MPEV1D Series

Notice of Magnetic Powder Binder Change

No.6230B-26159PE

Regarding the Change of Magnetic Powder Binder for the MPEV1D Series

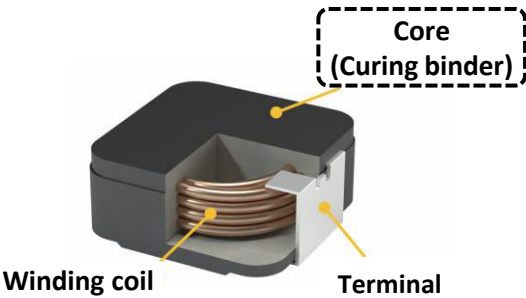
The binder used for curing the magnetic powder will be changed.

No changes will be made to the magnetic powder, terminals, wire, inductor manufacturing process, or product specifications.

Binder Type	Other Materials	Manufacturing Conditions	Electrical Characteristics	Reliability Tests
New Binder Version	Changed to an Equivalent Binder (High Heat Resistance)	No Change	No Change	Equivalent Performance (Refer to P-4)	Pass (Refer to P-5~9)
